**ADDENDUM NO. 2
TO THE
BIDDING DOCUMENTS
FOR
PRIMARY FILTRATION PROJECT (PHASE I)
CAPITAL PROJECT NO. 2022
FOR THE
FOUR RIVERS SANITATION AUTHORITY
ROCKFORD, ILLINOIS**

DATE: January 6, 2022

This Addendum No. 2, dated January 6, 2022, to the Invitation to Bid: Primary Filtration Project Phase I, Capital Project No. 2022, bid opening January 11, 2022 at 9:00 A.M., supersedes all contrary and conflicting information in the above-mentioned instructions, specifications, and contract documents which are hereby supplemented or revised in certain particulars as follows:

Sheet No.	48
Drawing No.	4-R-01

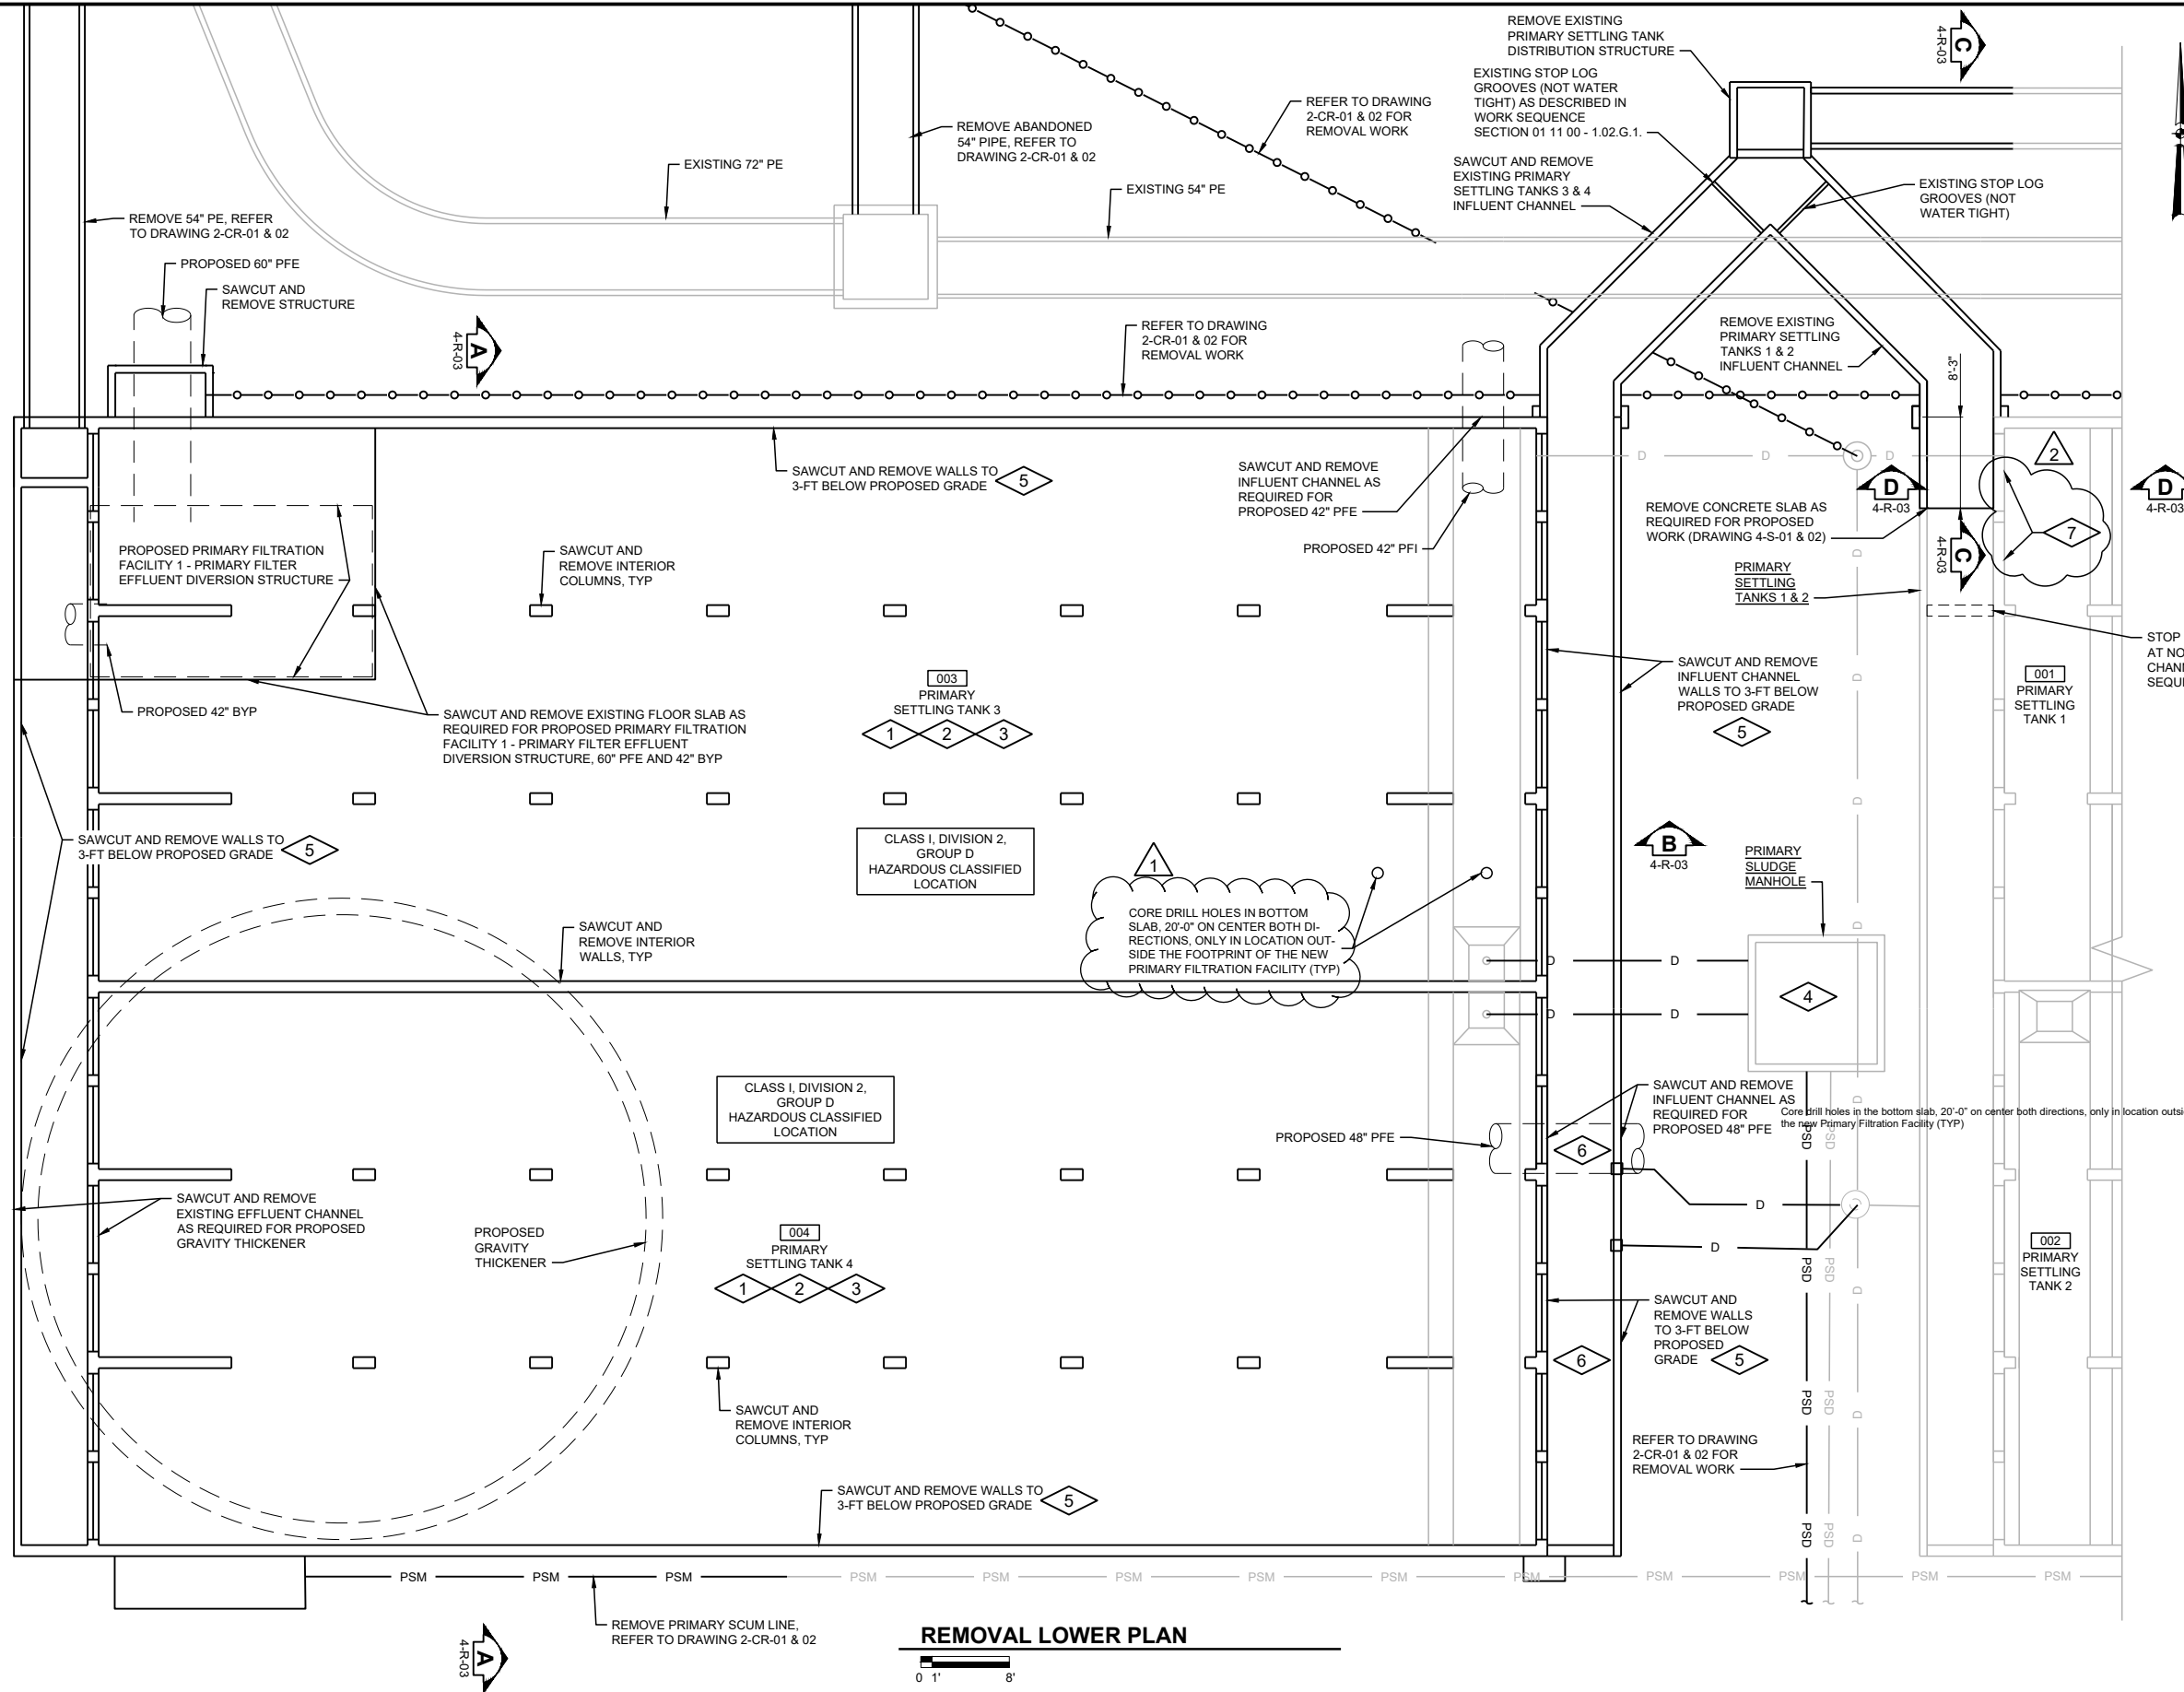
“5. Construct stop logs at north end of Primary Influent Channel for PST 1 and 2 (See Drawing 4-R-01 for location) and temporarily plug two (2) 11.5-inch x 7-foot inlet ports for PST 1 north of the stop logs to isolate proposed work at north end of Primary Influent Channel and allow bypass pumping into Primary Influent Channel.”
 - C. Page 01 11 00-5, subparagraph 1.02.G.8.b):

PRIMARY FILTRATION FACILITY 1
LOWER PLAN

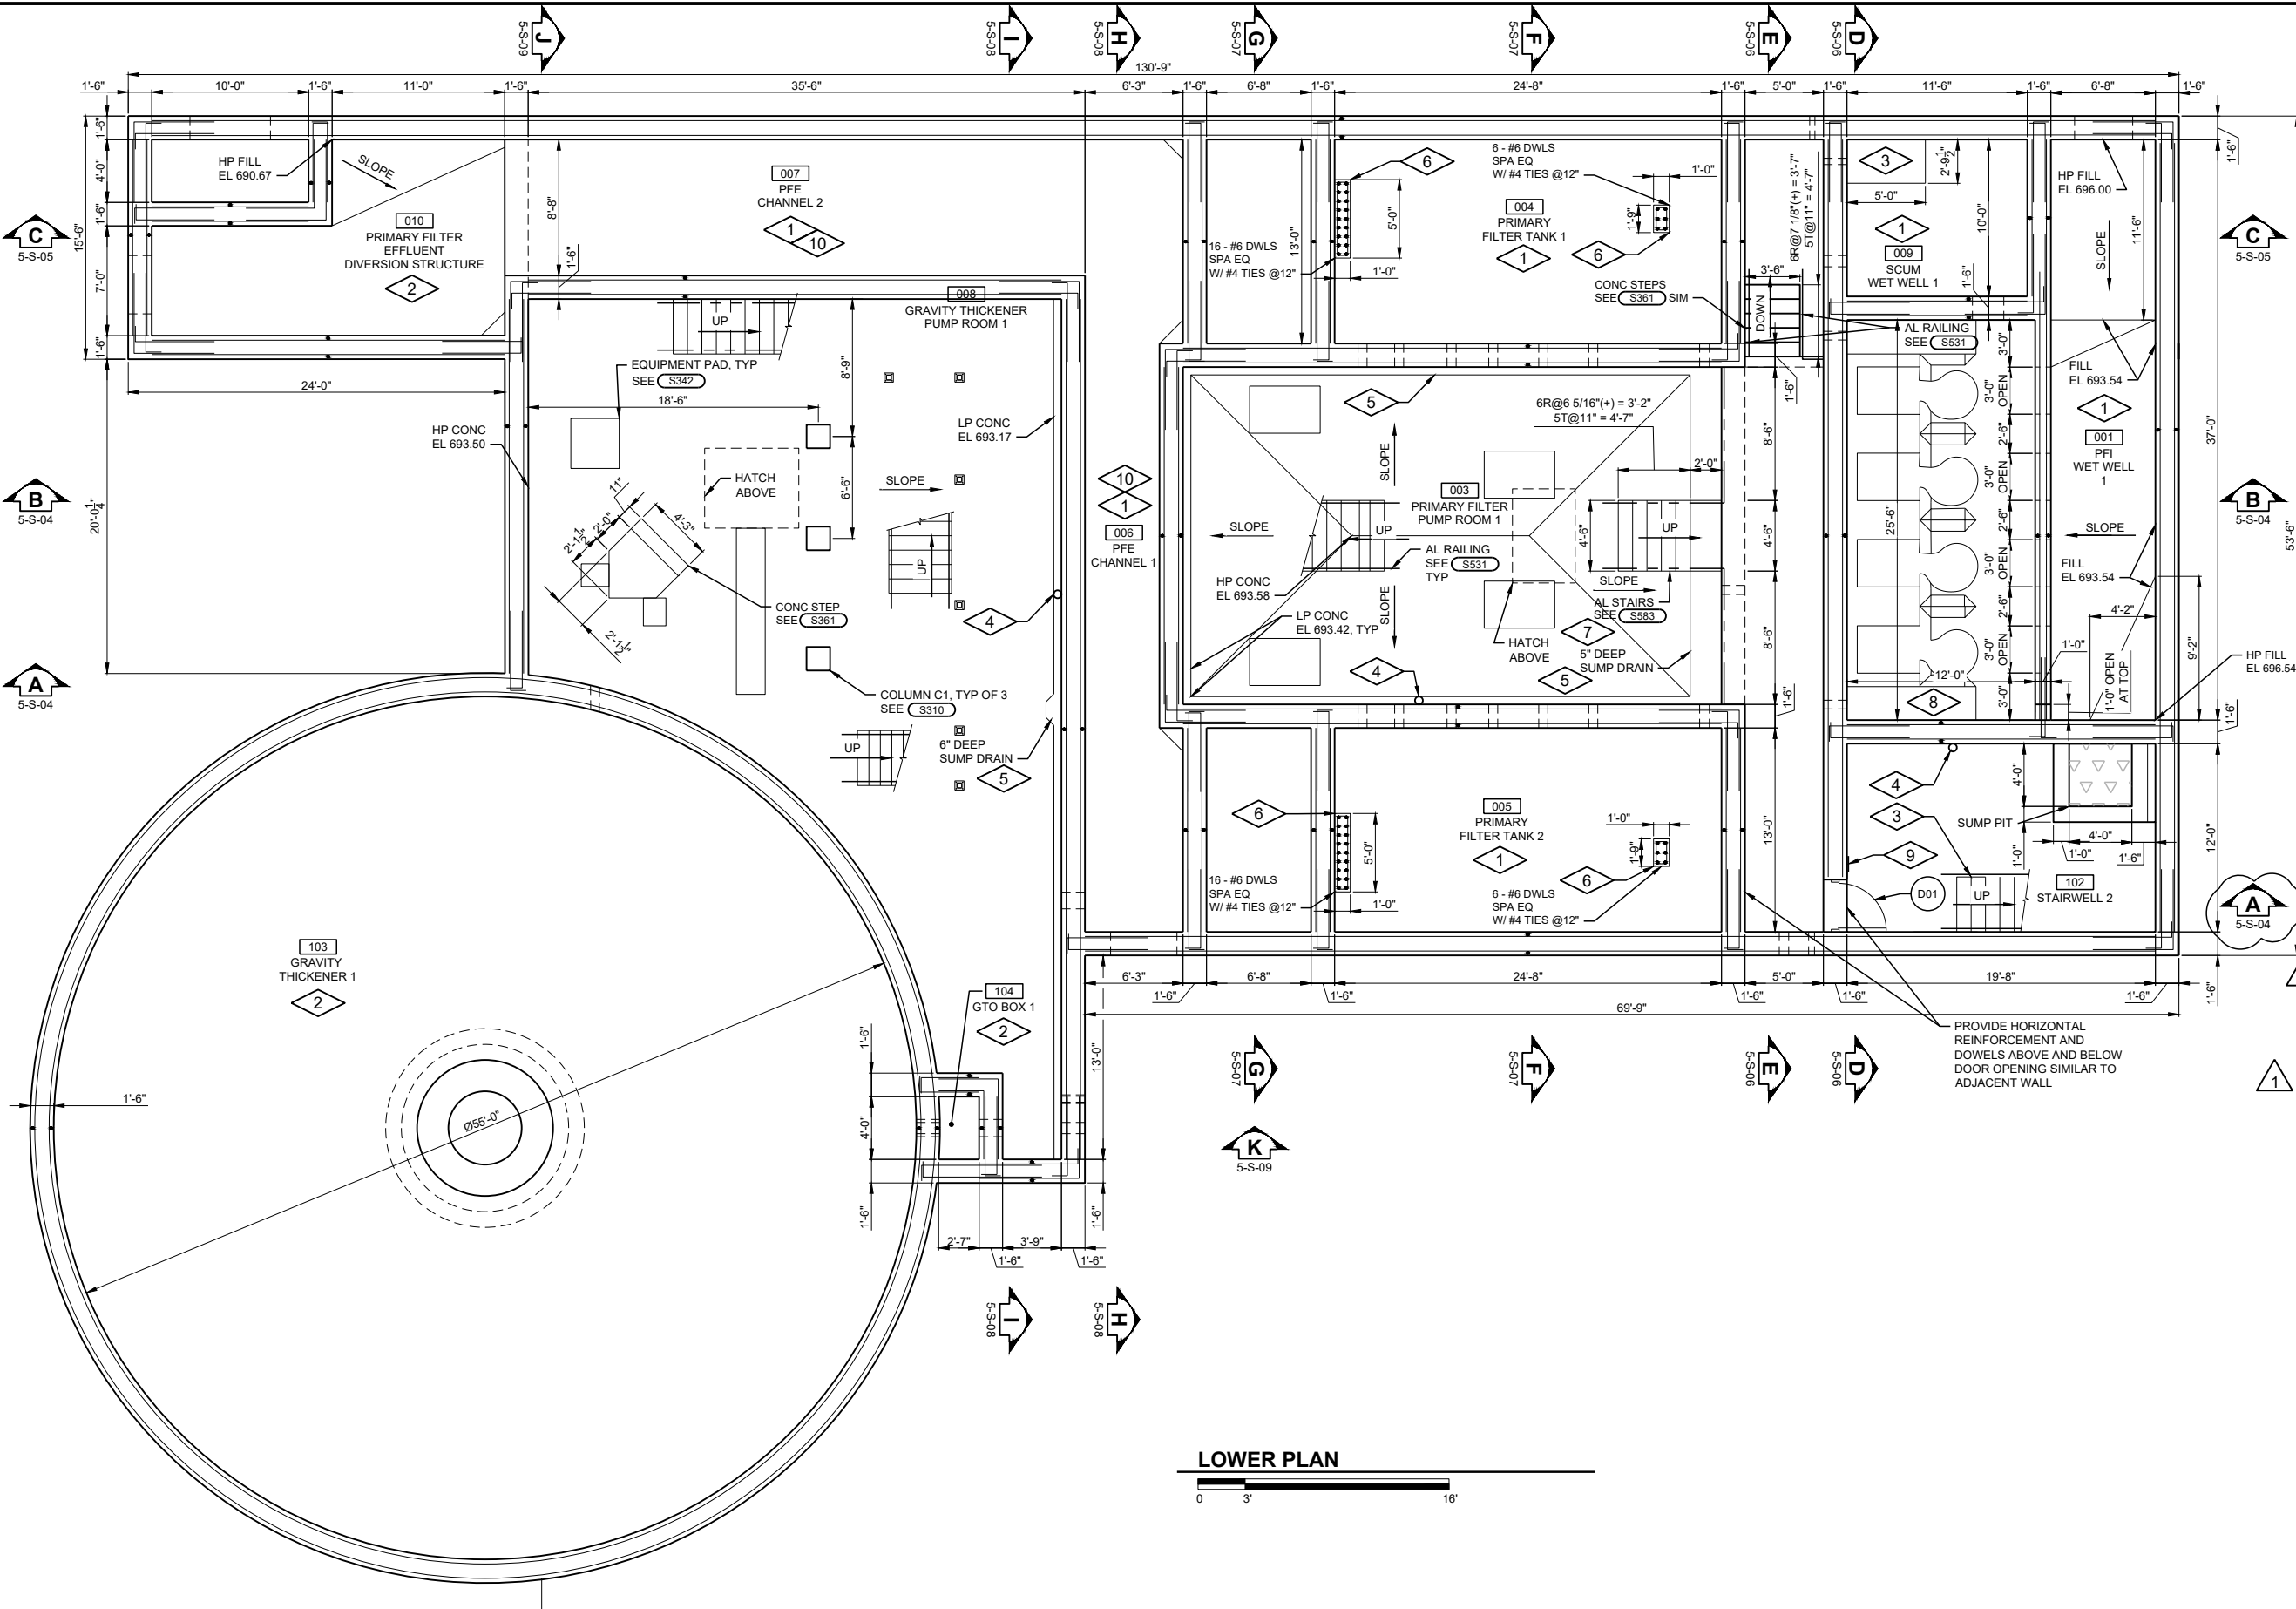
1. Paragraph 3.12.2 Insurance of Instructions to Bidders: No additional flood insurance is required.
2. For Sections A and B on Drawing 5-S-04 (Sheet 64) and Section C on Drawing 5-S-05 (Sheet 65): Channel and areas under PFI Wet Well 1 and Stairwell 2 shall be filled with mud mat with a 1" minimum thickness.
3. All concrete for Area 4 – Primary Filter Distribution Box and Area 5 - Primary Filtration Facility per SECTION 03 30 00, and Area 6 – Primary Tank Outlet Structure and Former Primary Tank Bypass Structure per Addendum 1 shall include a waterproofing admixture per SECTION 03 30 00.
